AprilAire 800 Series Steam Humidifier Electrode Wire Replacement Product Safety Notice

***by HVAC Distributors*October 12, 2022**

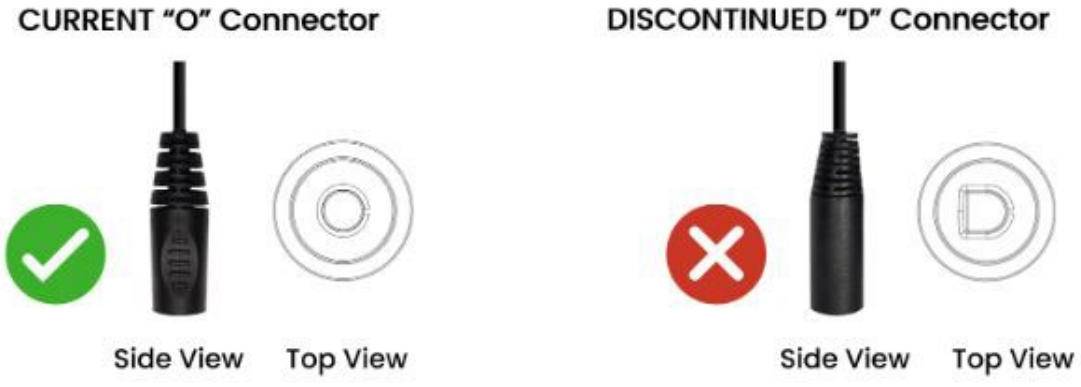
In steam humidifiers produced from 2010-2015, the electrode wires used a D-shaped connector that could become loose over time, causing poor electrical conductivity within the canister. This could, in turn, potentially lead to a thermal event rendering the unit inoperable.

During annual maintenance, contractors should remove from service any “D” shape electrode wires. In addition, replace any “O” shape electrode wires that are loose, damaged, or have been in service for 3 or more years.

Check your inventory of part #4978. Link to request FREE replacement of “D” shape electrode wire inventory with “O” electrode inventory.
